LS POWER GRID CALIFORNIA's POWER THE SOUTH BAY PROJECT

Final Environmental Impact Report Volume III – Comments and Responses to Comments on the Draft Environmental Impact Report

November 2025, Revised December 2025

A.24-05-014

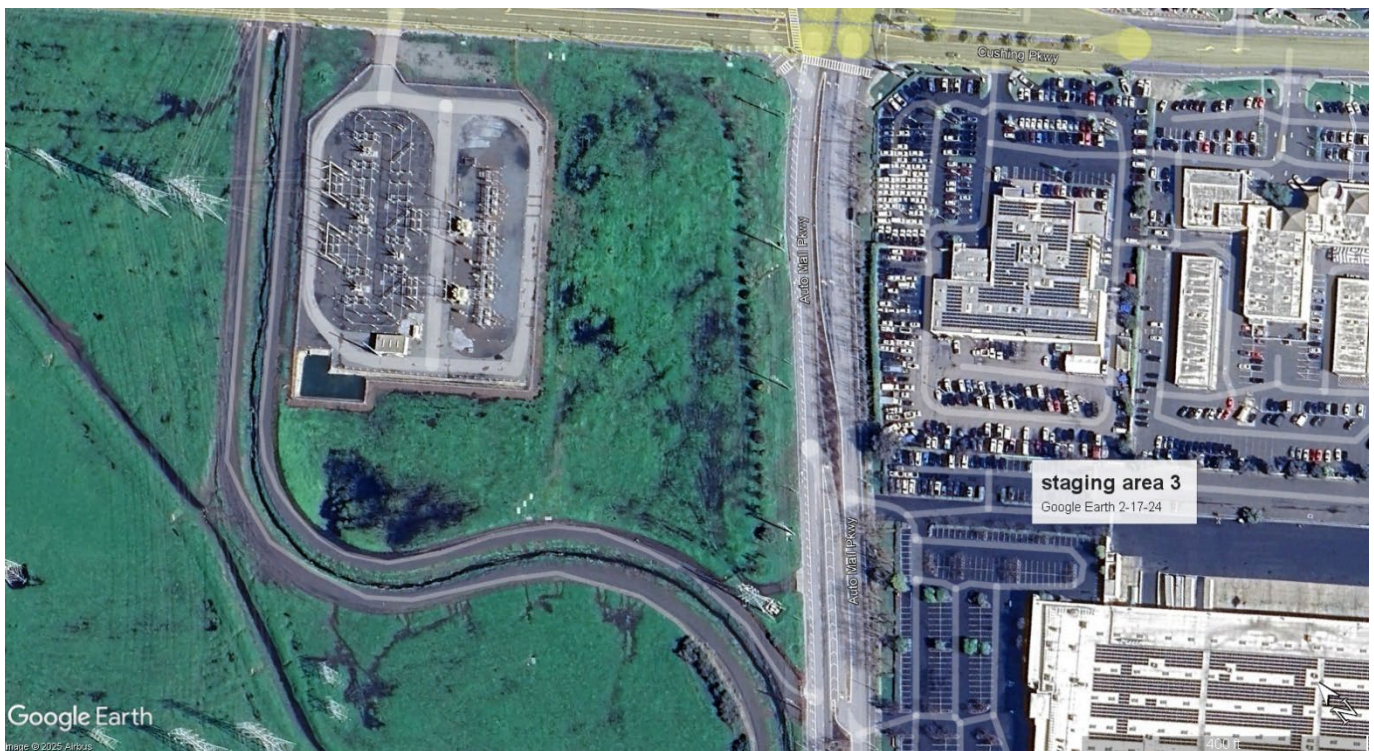
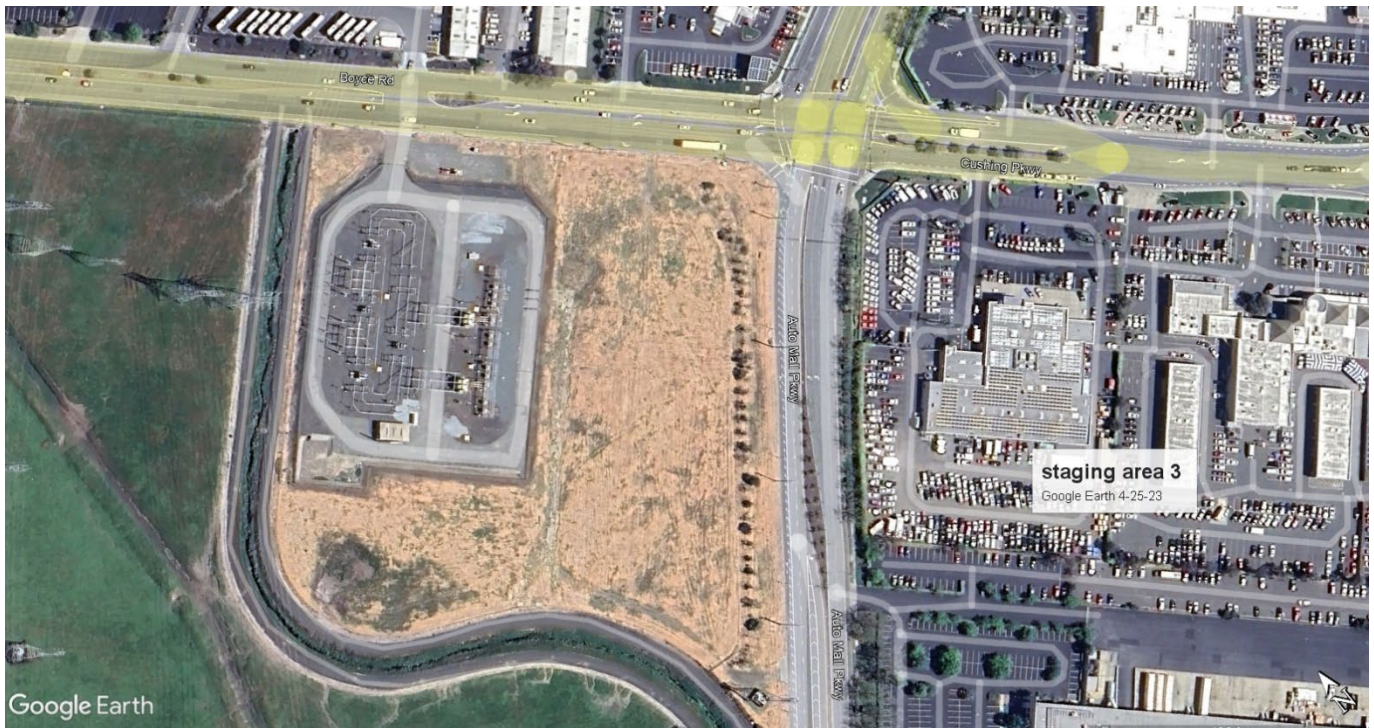
Figure 3.4-1A depicts two habitat types within Staging Area 3 – “disturbed” and “annual grassland.” Our review of Google Earth aerial images suggest that wetlands habitat that has persisted in the same location since 2006 have not been mapped.

The area of interest is outlined in red in the Google Earth image from March 13, 2006 and appears in aerial images from April of 2023 and February of 2024.

- O1-4 CCCR states that the Draft EIR omitted existing wetland habitat within Staging Area 3 in Figure 3.4-1A. CCCR urges that the vegetation community for Staging Area 3 be verified and that Staging Area 12 be reviewed for potential waters of the U.S./State. CCCR further states that the EIR must include maps that clearly delineate the location of jurisdictional waters/wetlands and lists of rare plants. As explained in Section 3.4 of the EIR, LSPGC has committed to conduct protocol surveys for rare plants in suitable habitat pursuant to **APM BIO-2: Rare Plant Surveys** as well as to conduct a wetland and aquatic resources delineation on all portions of the proposed Project containing potentially State or Federal jurisdictional waters pursuant to **APM BIO-19: Wetland and Aquatic Resources Delineations**. As discussed in Section 3.4.6 of the EIR, prior to filing its CPCN application with the CPUC, LSPGC conducted wetland and aquatic resource delineations at the area along Coyote Creek near McCarthy Boulevard and the RWF, as well as on both the north and south sides of the Cushing Parkway Bridge. Aquatic resource delineations would be conducted in all areas with potential for wetlands, including potential staging areas. In the Final EIR, APM BIO-19 has been revised to expand the boundaries of wetland and aquatic resources delineation on all portions of the Project containing potentially State or Federal jurisdictional waters (i.e., not restricted to California Department of Transportation ROW), as follows:
